October 6, 2021

ATTN: Document Control Desk  
Director, Spent Fuel Project Office  
Office of Nuclear Material Safety and Safeguards  
U.S. Nuclear Regulatory Commission  
Washington, DC 20555-0001

Subject: RESPONSE TO REQUEST FOR ADDITIONAL INFORMATION FOR  
REVISION 25 OF THE TRUPACT-II SHIPPING PACKAGE APPLICATION,  
DOCKET NO. 71-9218, AND REVISION 8 OF THE HalfPACT SHIPPING  
PACKAGE APPLICATION, DOCKET NO. 71-9279  
(EPIDS L-2021-LLA-0033 AND L-2021-LLA-0034)

**FIGURE 1** – HalfPACT Package with Two SC-55G1s; Shifted Point Source

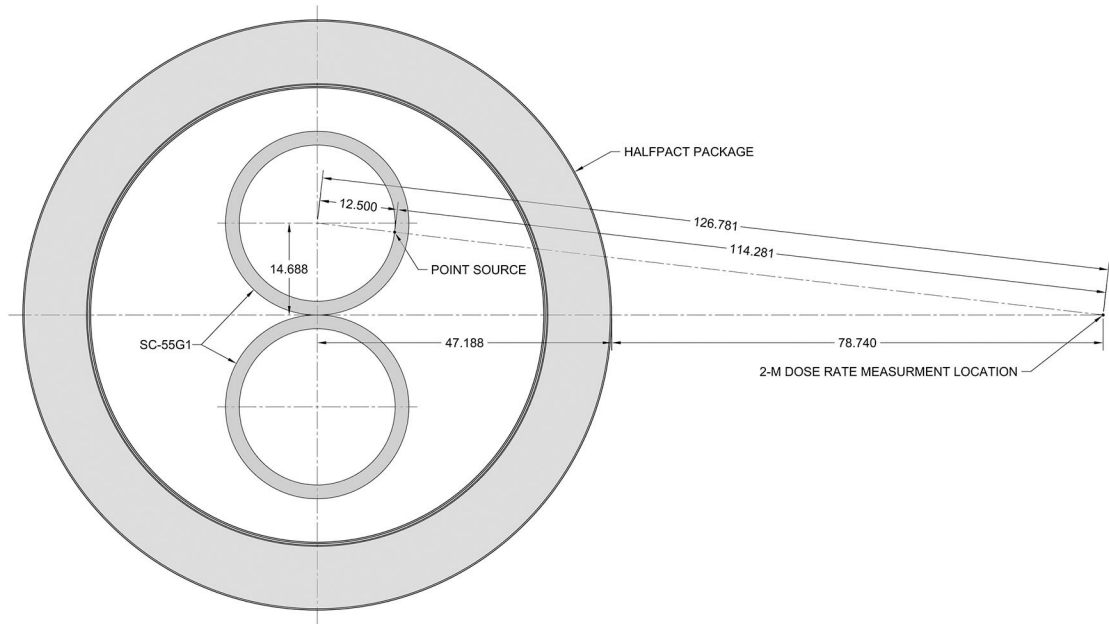
under NCT where the combined sum of partial fractions for gamma and neutron source terms are required to be less than or equal to 0.9. As shown below, potential reconfiguration of the source material in the shielded containers under NCT is highly improbable and will not cause a significant change in the limiting package dose rate values. Other potential sources of dose rate increase under NCT are not applicable for shielded containers due to test results indicating no damage to the payload container under those conditions.

Using distance attenuation for the SC-55G1 configuration as an example, where the dose rate is directly proportional to the inverse square of the distance, the limiting dose rate of 10 mrem/hr at a distance 2 meters from the HalfPACT package surface containing two SC-55G1s with initially centered point sources that are unrealistically moved the full radial distance to the SC-55G1's inner shell surface would only increase to  $(126.781/114.281)^2 \times 10 = 12.3$  mrem/hr (see Figure 1). Similarly, the limiting dose rate of 10 mrem/hr at a distance 2 meters from the HalfPACT package surface containing one SC-55G2 with an initially centered point source that is unrealistically moved the full radial distance to the SC-55G2's inner shell surface would only increase to  $(125.928/113.448)^2 \times 10 = 12.3$  mrem/hr (see Figure 2).

Any substantial concentration of sources resulting from movement during transport would be readily observable during receipt inspection of the package, and none has been noted in thousands of CH-TRU waste shipments within the TRUPACT-II and HalfPACT packages.
